MEMO

TO: City Council
FROM: Planning & Development Services Department, Andrea Villalobos, Senior Planner
DATE: October 17, 2019
RE: Redwood Garage Alternative Compliance Appeal - Clarification

Garage Location Condition

Figure 1 (Current Code, semi-flush): Garage must be set-back 5-20' from the front wall plane.

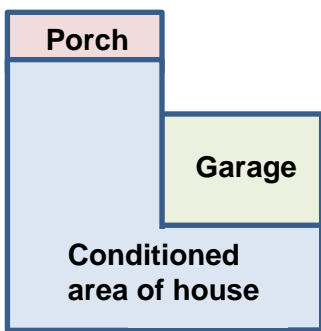
Current Code: In a “semi-flush” option per section 7.1.4.1 of the development code, a garage must be positioned between 5 and 20 feet behind the front wall plane of the house (Figure 1). Adding a porch to a house is optional, and the front of a porch is not considered a “front wall plane of a house”.

Approved Alternative Compliance Language: Per the approved condition, all garages in the subdivision must be positioned behind or flush with the front most protrusion of the house. Under this condition, a garage can either be built to current code standards (Figure 1), flush with the front wall plane of the house (Figure 2), flush with a protrusion, such as a porch, (Figure 3), or behind a protrusion, such as a porch (Figure 4).

Figure 2: Garage is flush with the front wall plane

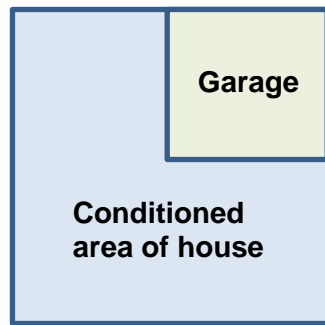
Staff Recommended Revision to Language: In order to ensure the above intent is achieved, staff recommends adding the following language in red to Condition #3. This condition clarifies that a maximum of 50% of the homes can look like Figure 2, 3, and 4. The remaining homes must meet current code.

In no case shall the garage be the front most protrusion of the home, but it may be flush on a maximum of 50% of the homes within the development. For the purposes of this condition, a front porch is considered a protrusion of the home.

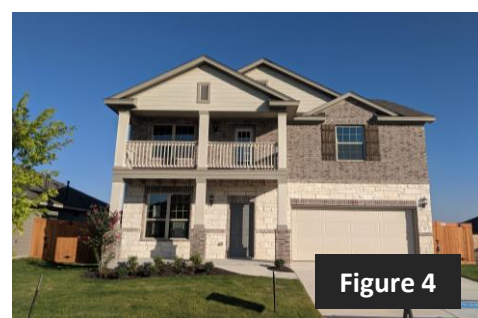
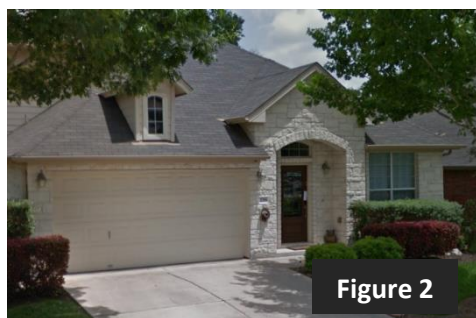
During the motion, it was unclear whether Council approved this language. The purpose of this language was to ensure that the front door be flush with the front façade (Figure 5) rather than recessed (Figure 6).

In no case shall the garage be the front most protrusion of the home, but it may be flush on a maximum of 50% of the homes within the development. For the purposes of this condition, a front porch is considered a protrusion of the home. Where the garages extend past the front façade of the house, the front entry door shall be flush with the façade, and/or not be set back as to cause a recessed entry.

Figure 7: Porch extends in front of the front wall plane of the house.

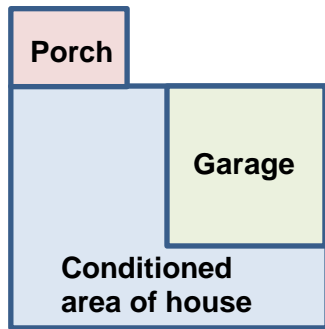
At the October 15, 2019 meeting, Council increased the percentage of porches that are required throughout the subdivision from 25% to 50%. As currently written below, a porch must “extend in front of the front façade of the house” (Figure 7). However, condition #3 states that a front porch can be flush with a garage (Figure 8) and is not required to extend in front of the front façade of the house. Therefore, staff recommends revising the language as follows to ensure consistency with condition #3.

A front porch shall be required on a minimum of 50% of the homes. The front porch shall ~~extend in front of the front façade of the house and shall~~ be a minimum of 6 feet of clear space in all directions and shall have a minimum area of 60 square feet;
